RE: **Grants Reclamation Project – DP-200 Renewal – Response to September 12, 2000 NMED Letter Transmitting Comments / Questions on Renewal Application**

**HOMESTAKE MINING COMPANY
Grants Reclamation Project
DP-200 Renewal**

**RESPONSES TO
NEW MEXICO ENVIRONMENT DEPARTMENT
REGARDING QUESTIONS / COMMENTS ON DP-200
RENEWAL APPLICATION
PER
NMED LETTER DATED SEPTEMBER 12, 2000**

FIGURE 35. SELENIUM CONCENTRATIONS FOR WELLS D1, X, S4, F, FB AND GH.

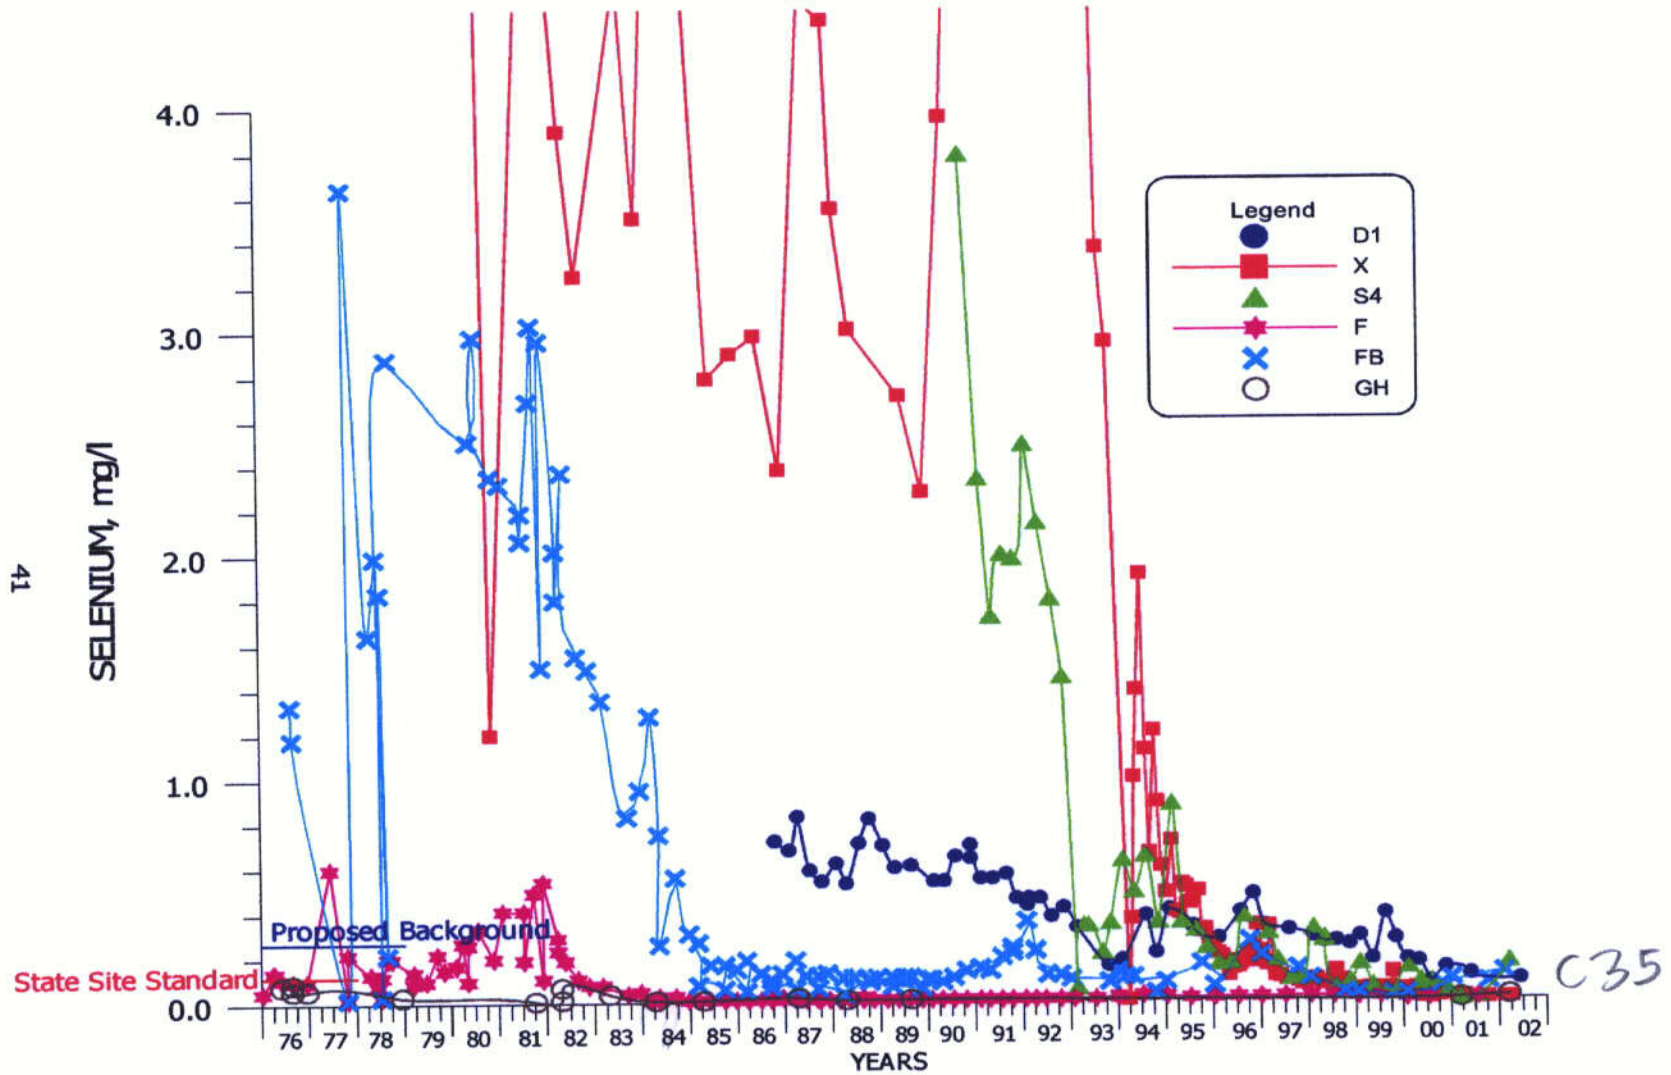
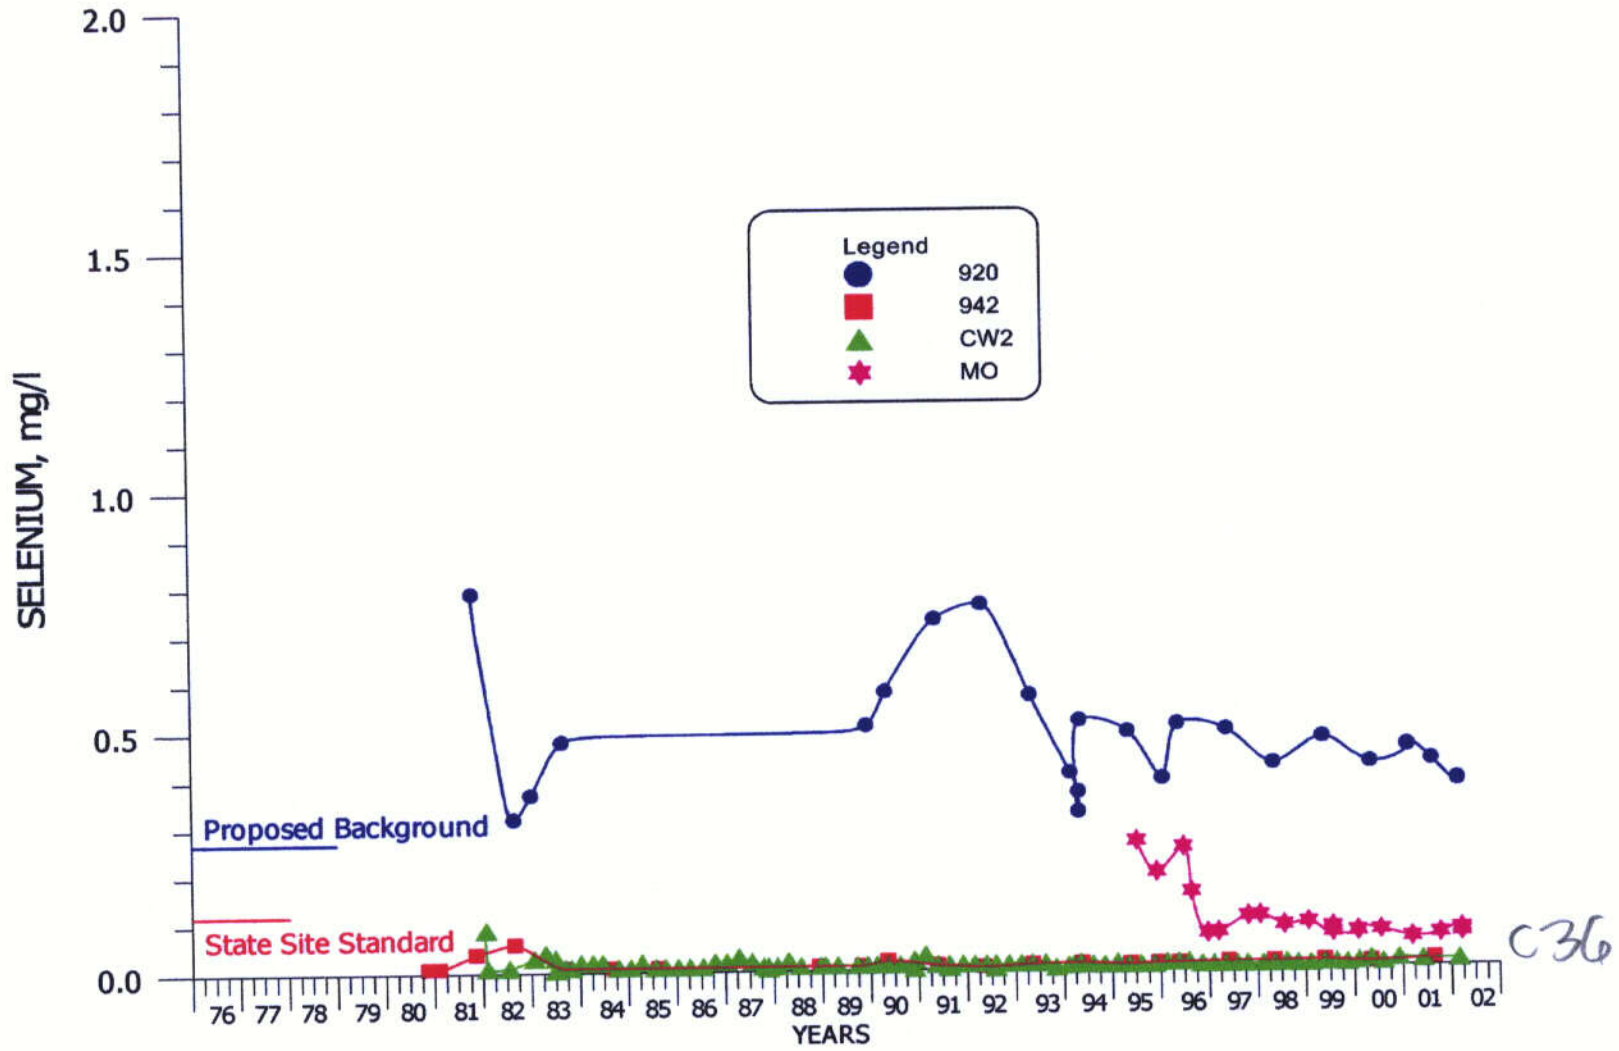
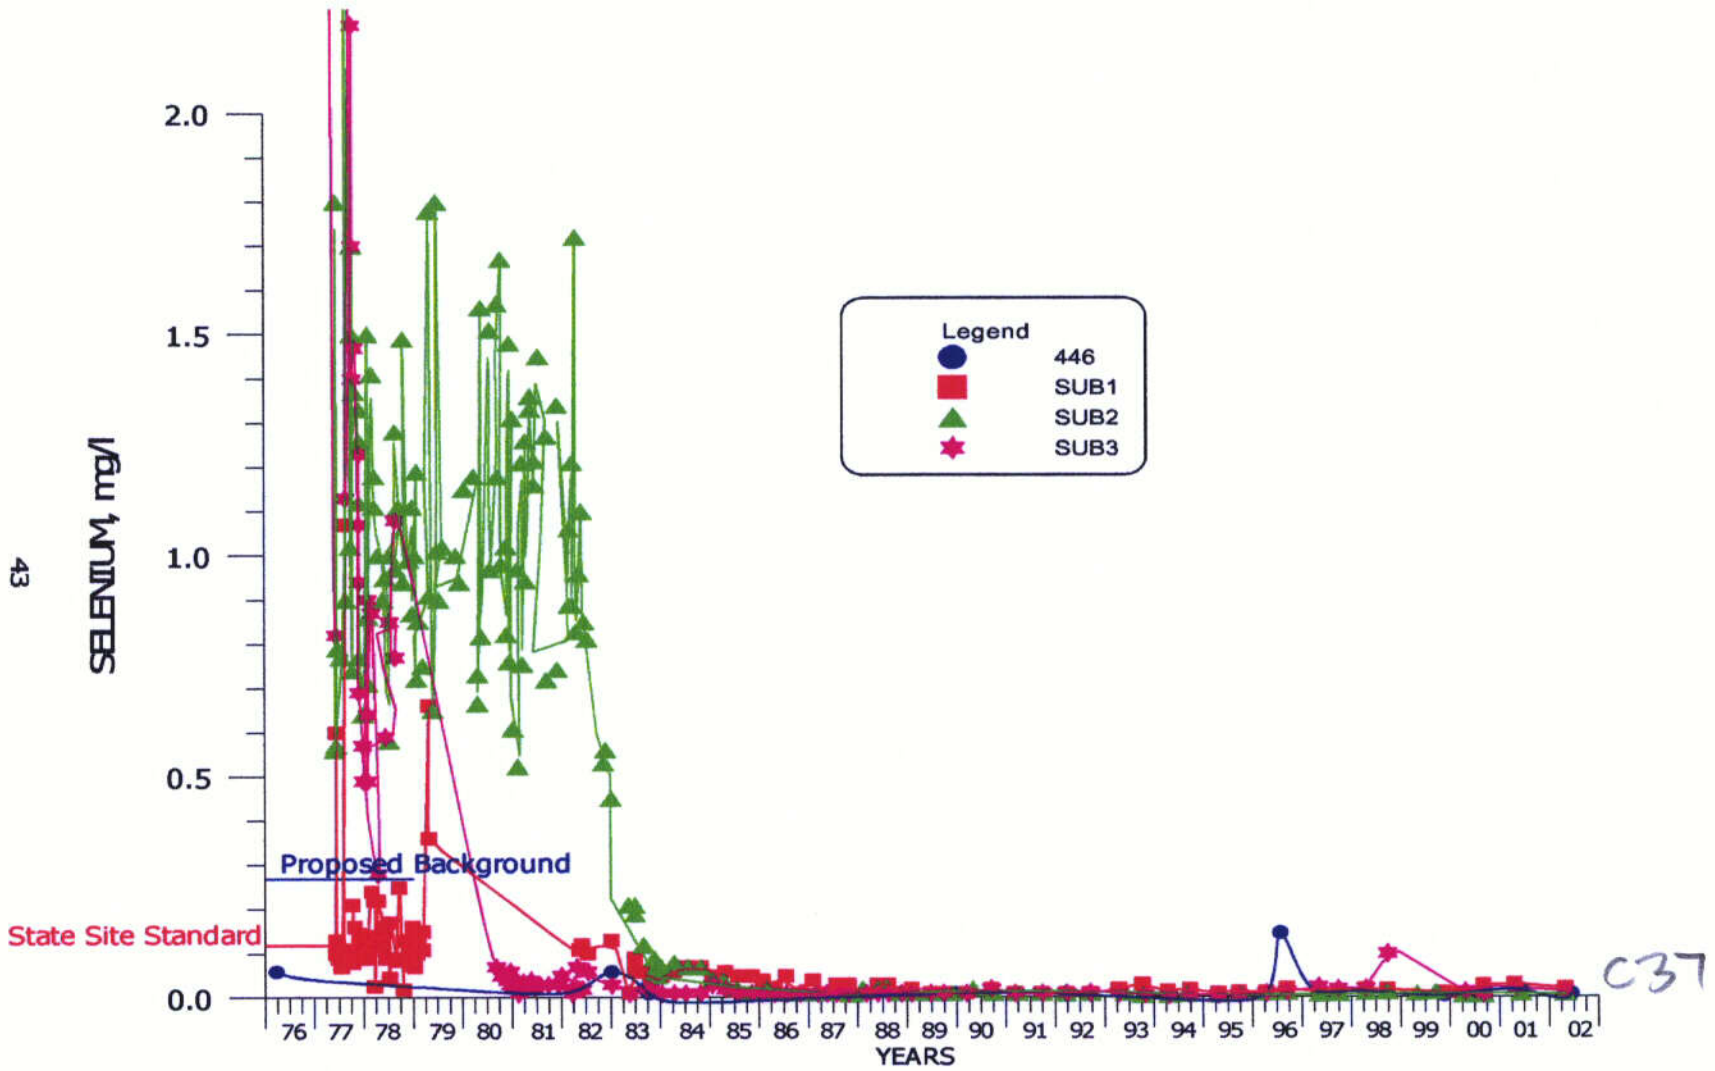
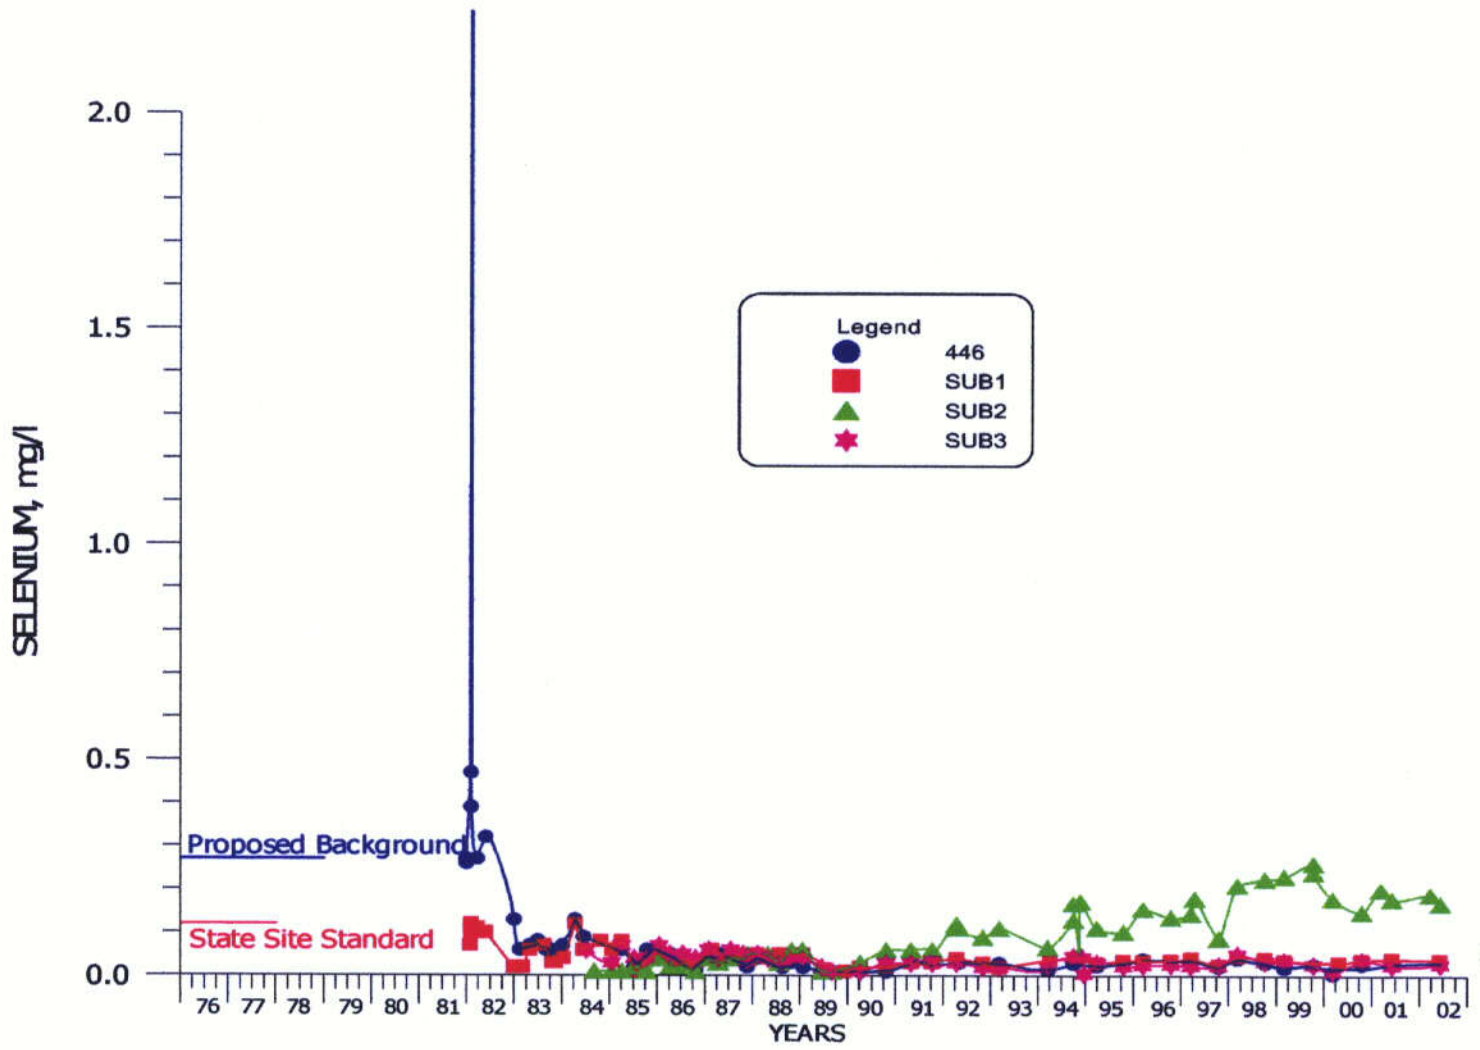
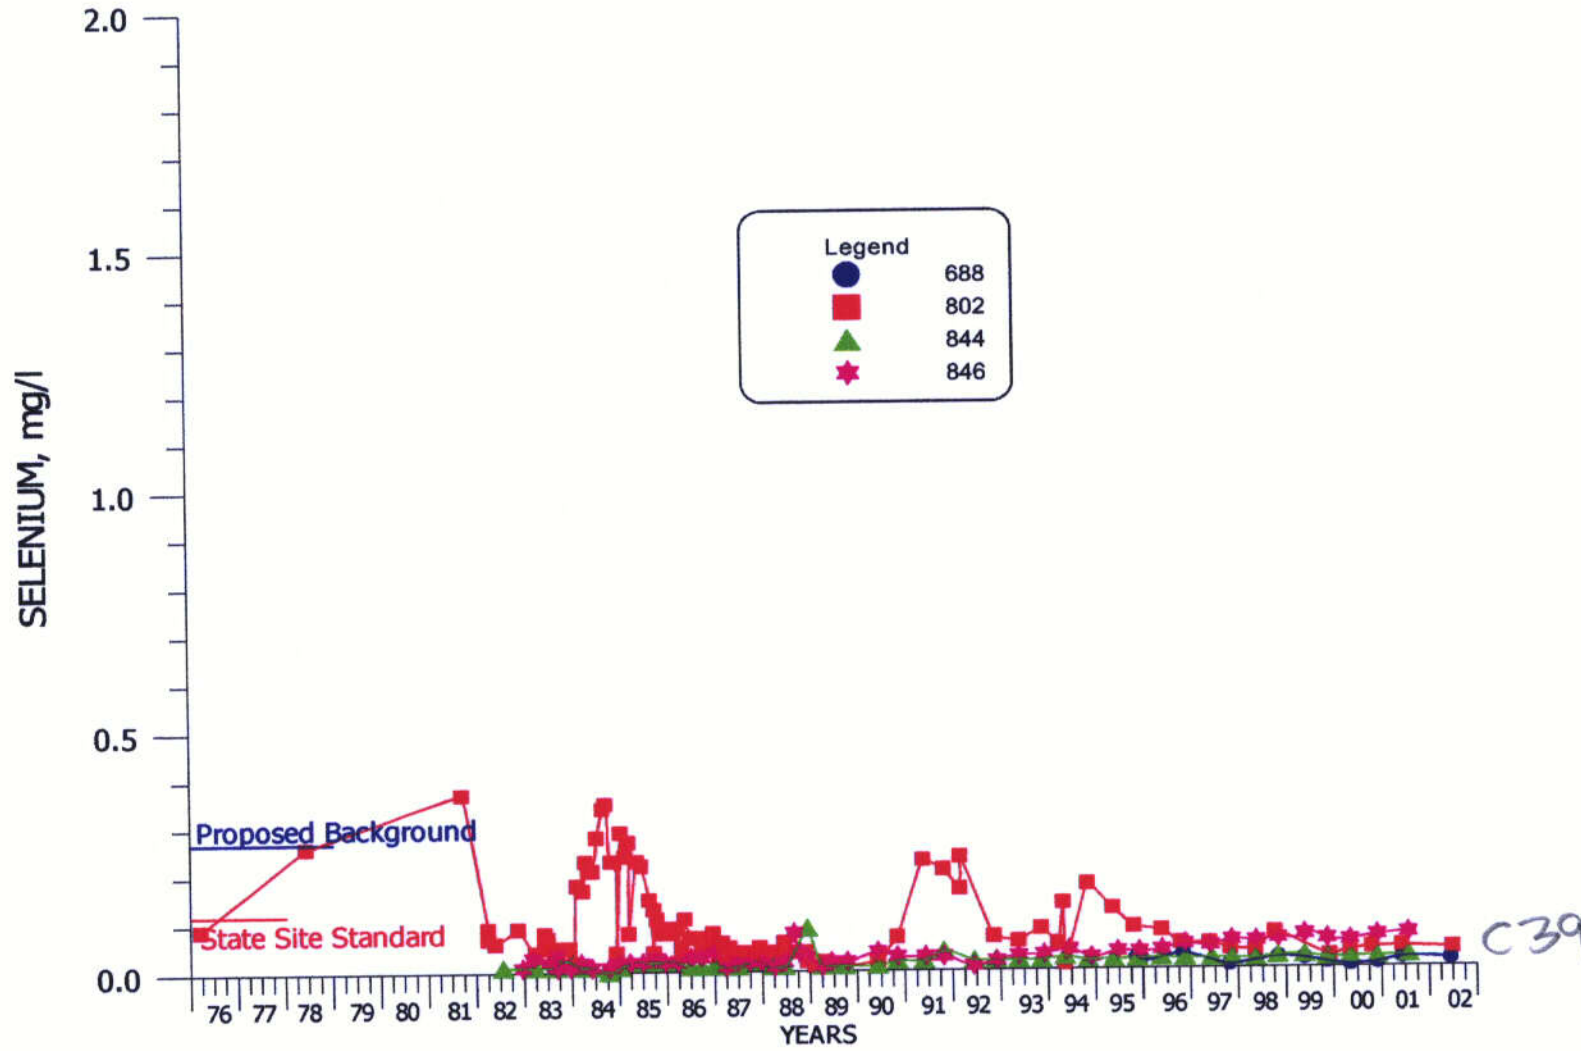
Comment: III.1.B. Graphs of Water-quality Data for the Table 2 Wells

Response: Plots for the routine monitoring wells from Table 2 of the NRC license are presented for sulfate, TDS, chloride, uranium, selenium, molybdenum and nitrate concentrations as Figures 15 through 49. The first group of wells for each of these constituents are presented for the three POC wells (Wells D1, X and S4) and

the initial figure also includes on site wells (Wells F, FB and GH). The following tabulation lists the figure numbers for each of the constituents:

CONSTITUENT	FIGURE NUMBER
SO4	15 – 19
TDS	20 – 24
Cl	25 – 29
U	30 – 34
Se	35 – 39
Mo	40 – 44
NO3	45 – 49

A few different vertical scales were required due to the large variations in parameter concentrations. The present State standard and the proposed background concentrations are presented on the plots.
